Subject: Chula Vista Energy Upgrade Project (07-AFC-4)  
Data Request Response to CEC Staff Data Requests 1 through 47 and Workshop  
Query 1

Application for Certification  
For the **CHULA VISTA ENERGY  
UPGRADE PROJECT**

**Response to CEC Staff Data Requests  
1 through 47 and Workshop Query 1**

**Attachment DR37-1**  
**Historical Maps**

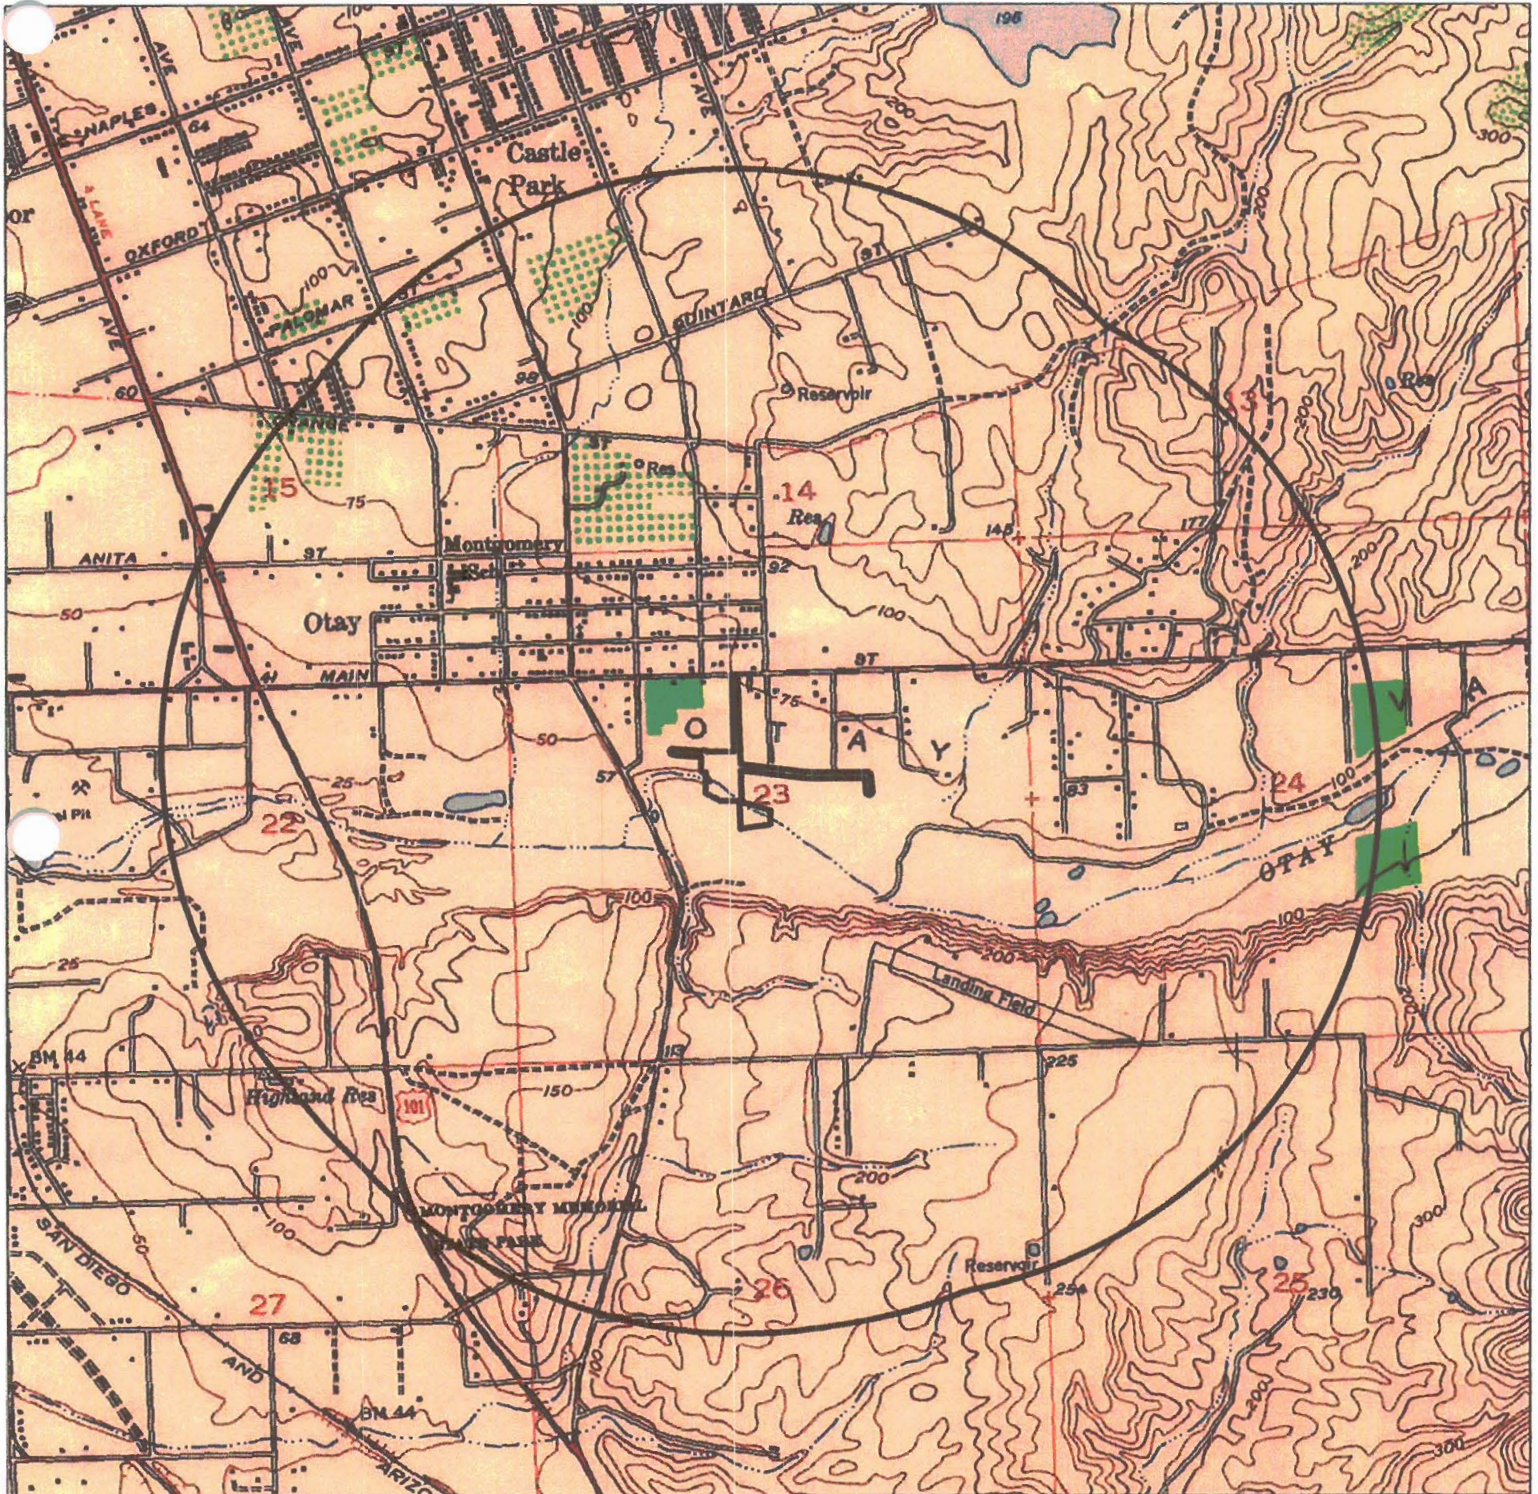
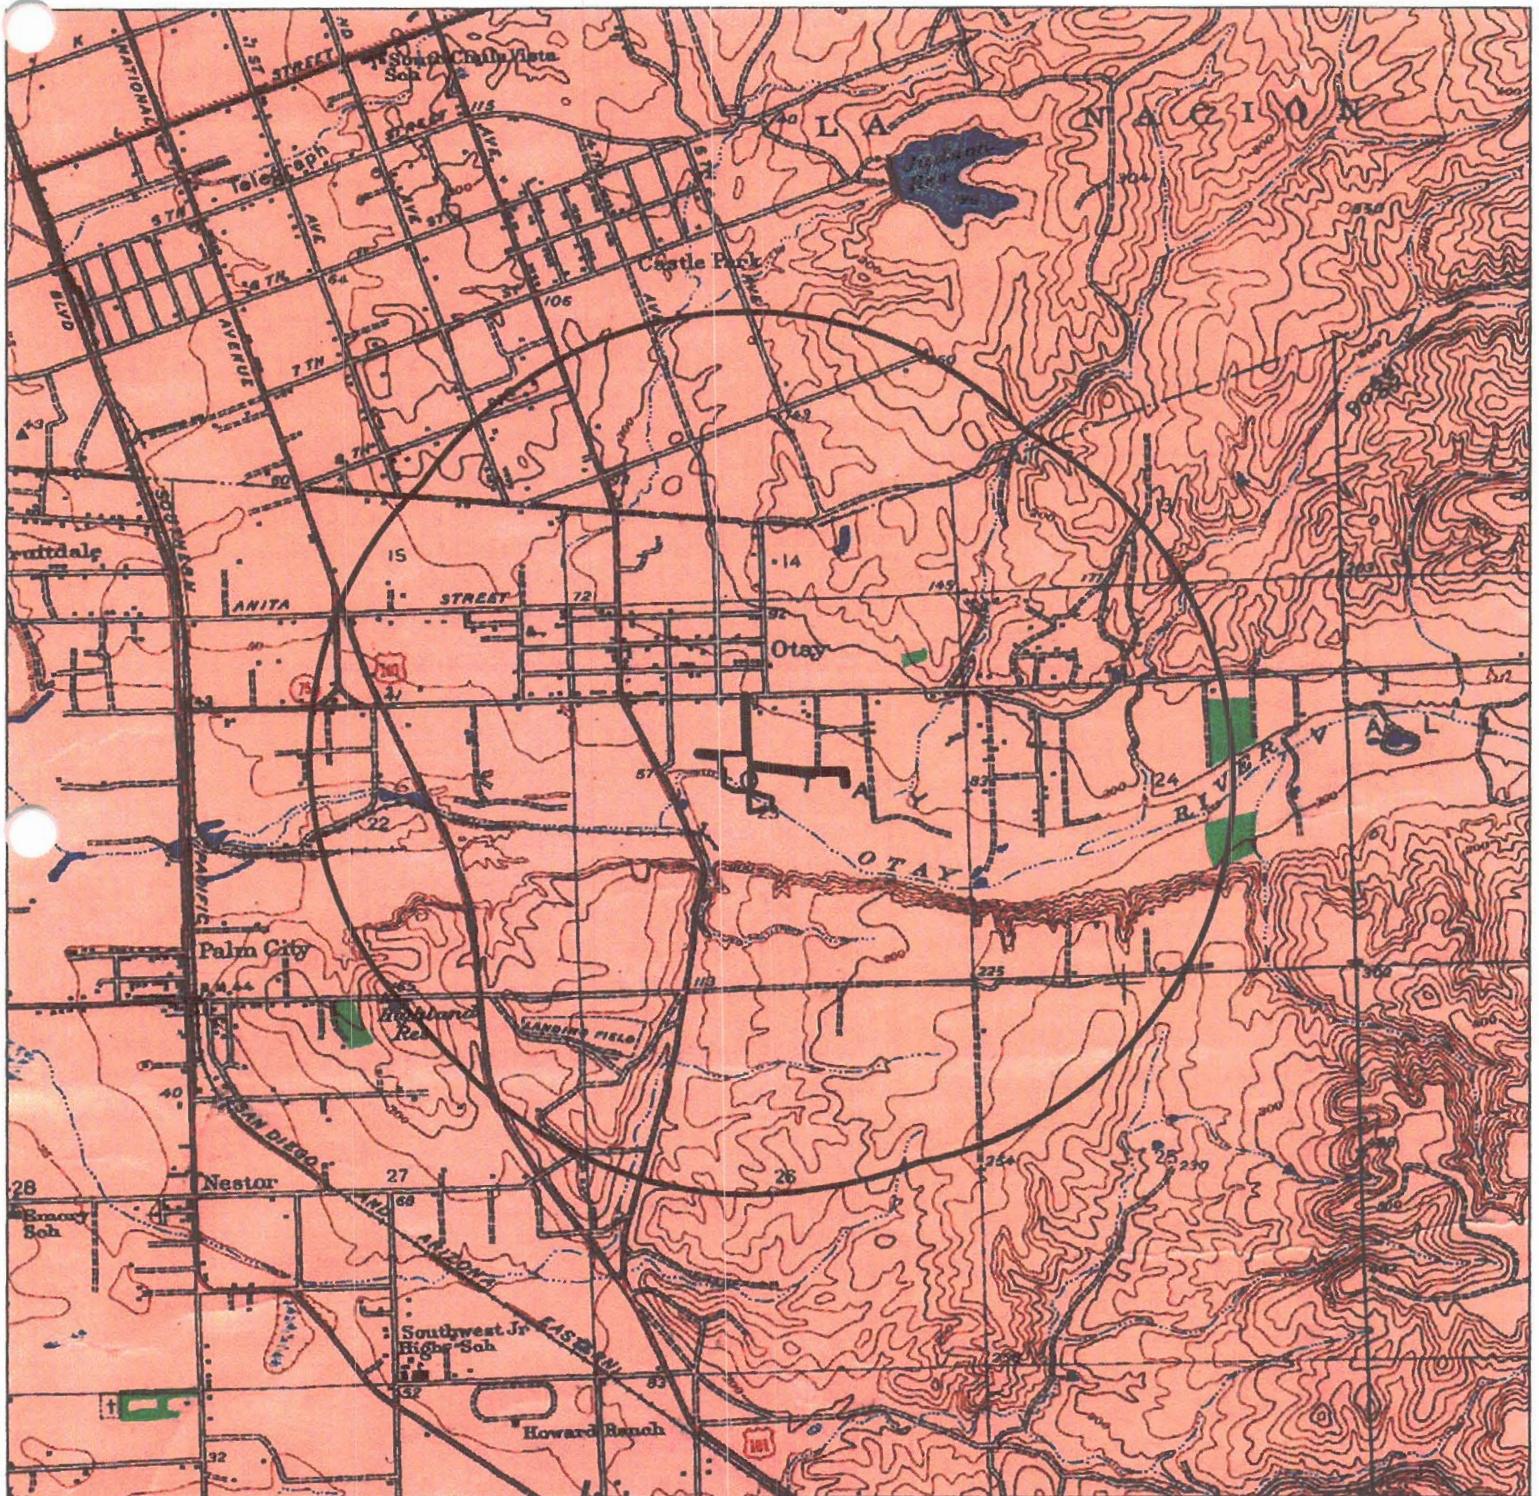
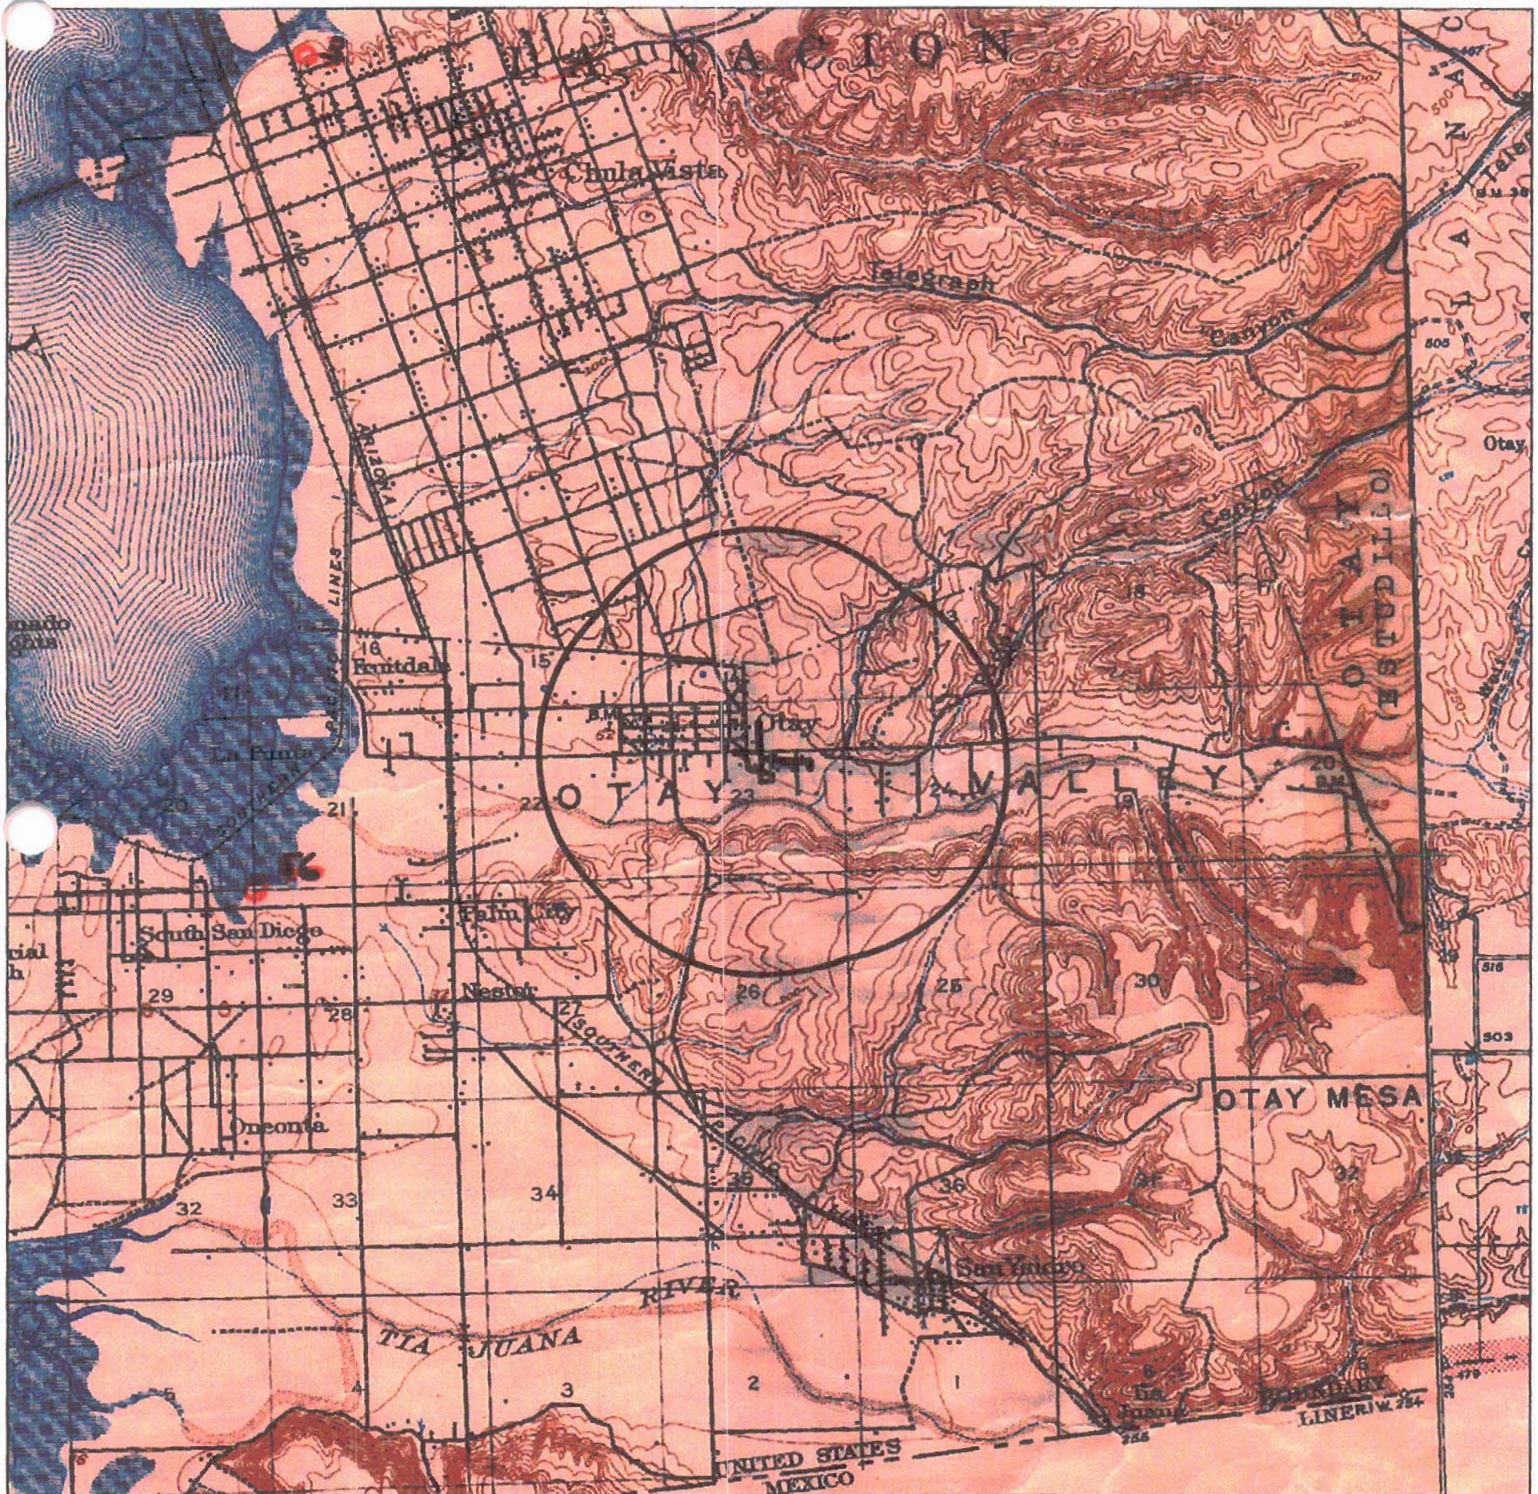
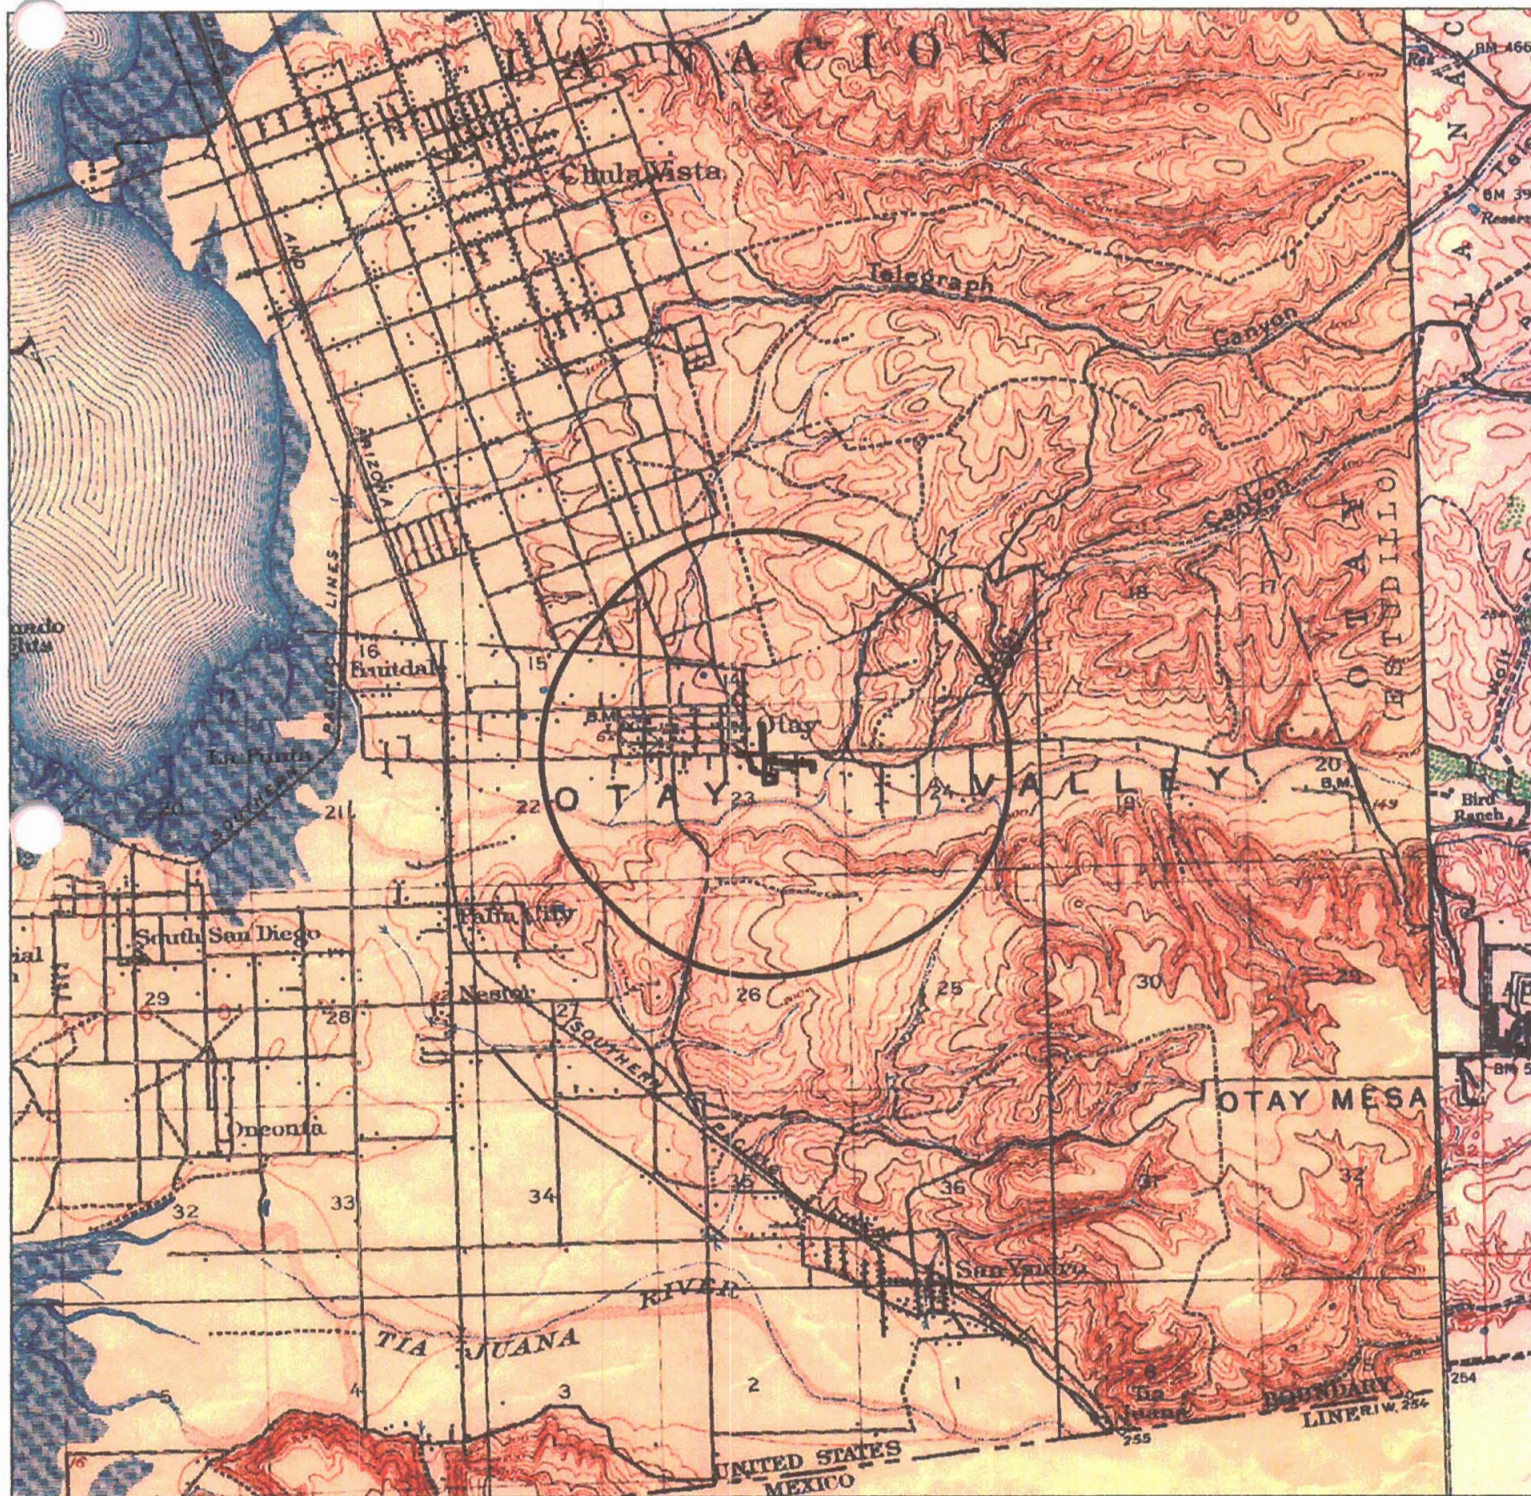
37. *Please provide copies of any historic maps received from the CHRIS that were not included in the previously submitted confidential filing.*

**Response:** Historical maps provided by the CHRIS are attached as Attachment DR37-1.
